SUBJECT: File No. 1251H2A-19 and 1251H2A-19
SITE INSPECTION - Response
Proposed Residential Building Site
1065, 1067 & 1069 E Bradley Avenue
El Cajon area, County of San Diego

Per your email of January 24, 2022, the additional information you requested is as follows:

LOCATION OF
EXPLORATION TRENCHES

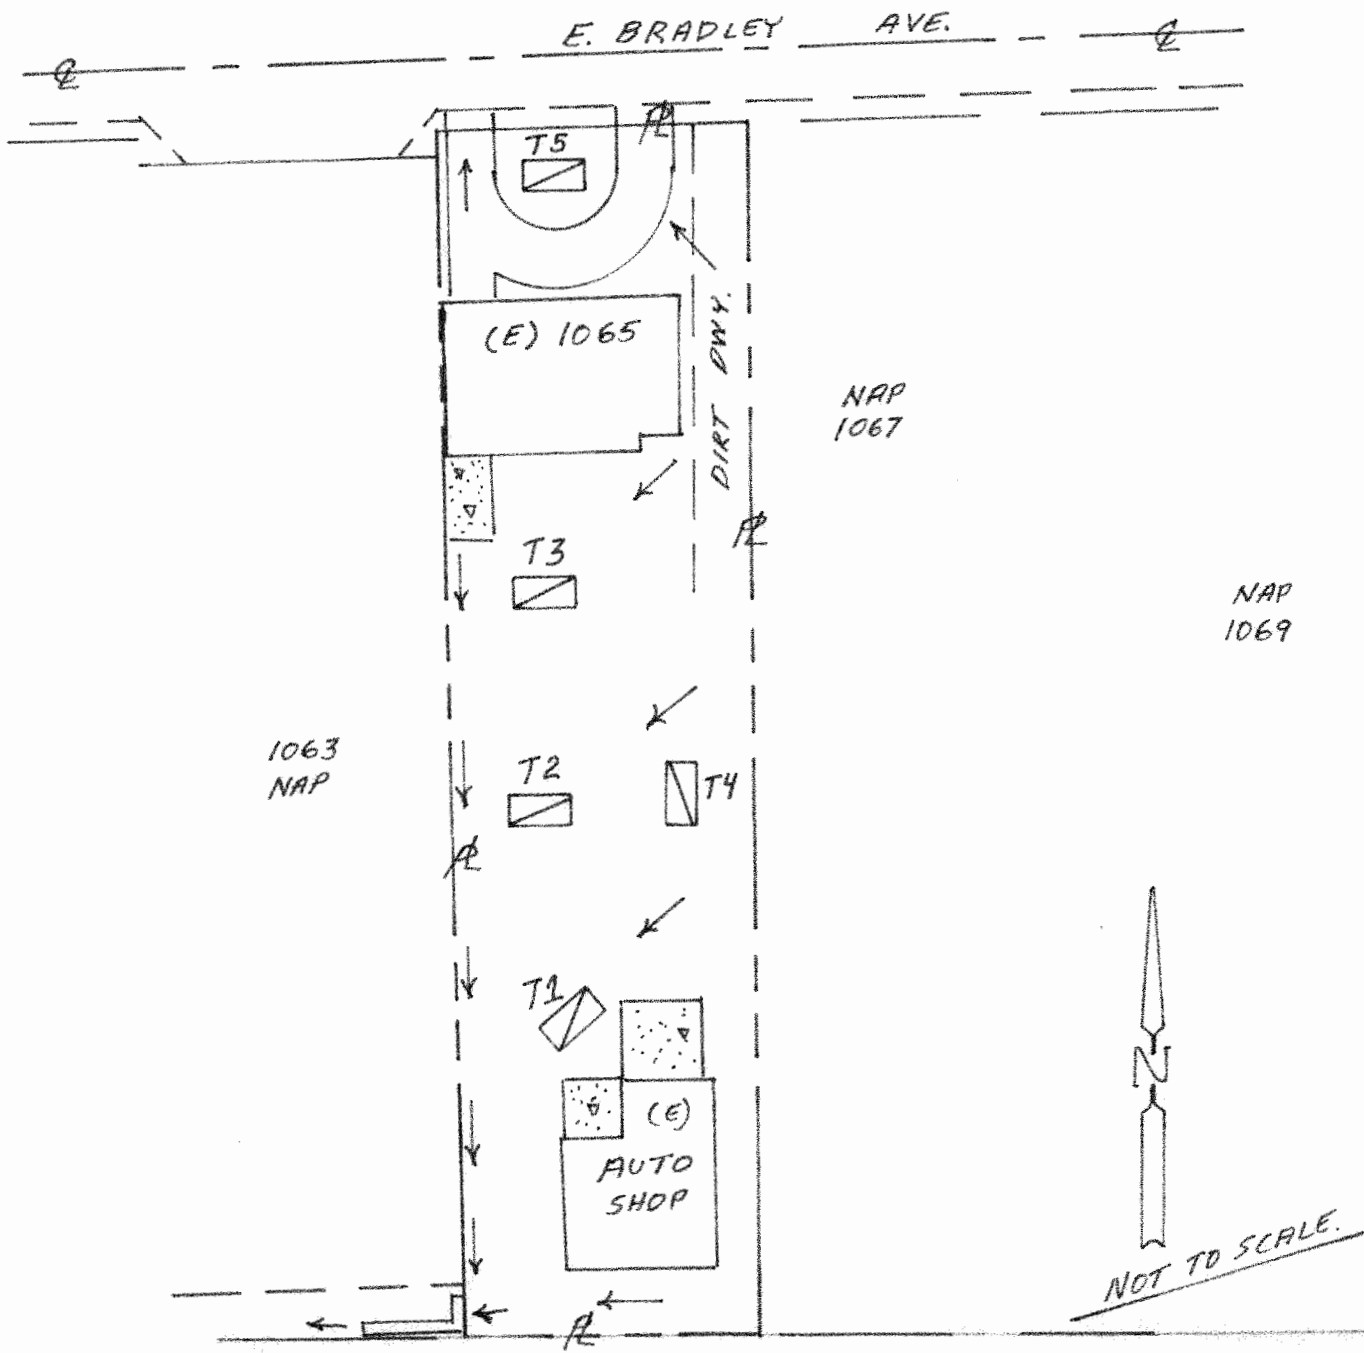
- d. Provide site investigation logs. Include a Geotechnical Map delineating geologic soil types and location of test pits and borings.

Please see attached updated reports with the logs and maps with the trench locations.
